**Comments of the Natural Resources Defense Council (NRDC) on the
Revised California Energy Demand Forecast 2012-2022 (Revised Forecast)**

Docket Number 12-IEP-1B
Demand Forecast
March 1, 2012

Figure 1: Electricity Demand in California ISO From 2008 to 2020¹⁰

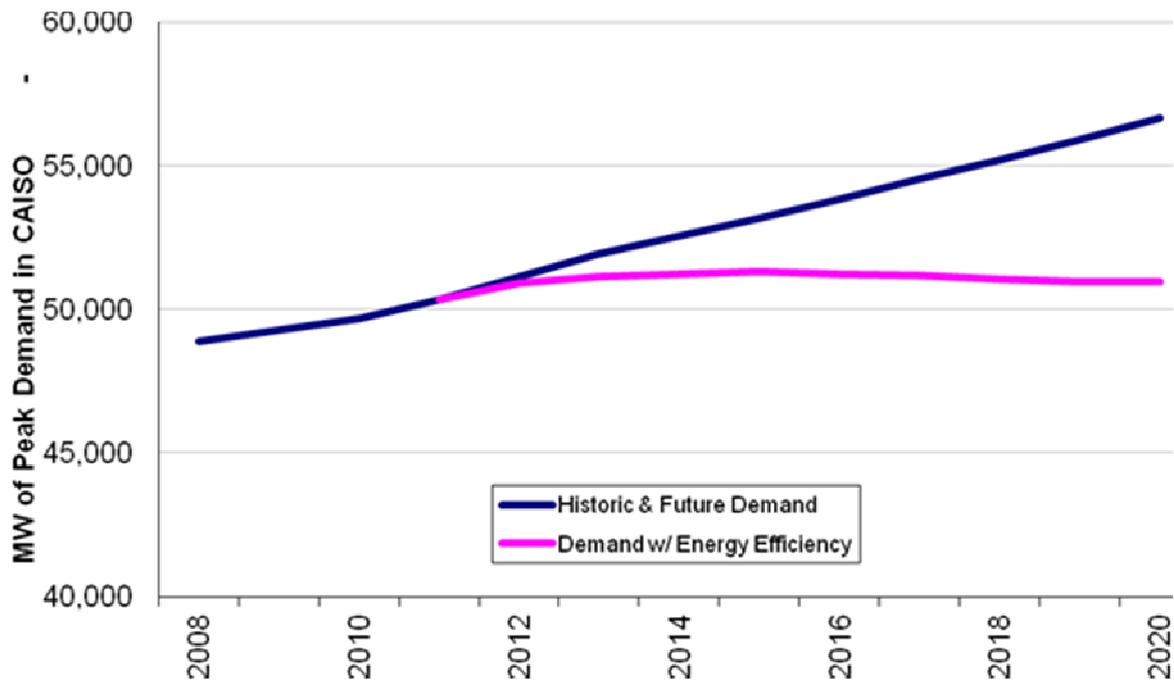
As shown in Figure 1, the difference between including future efficiency and failing to do so, is significant. It is absolutely essential that the CEC at least calculate the amount of uncommitted efficiency, even if it does not include it in its consumption projections, in order for other agencies to fulfill their duties.
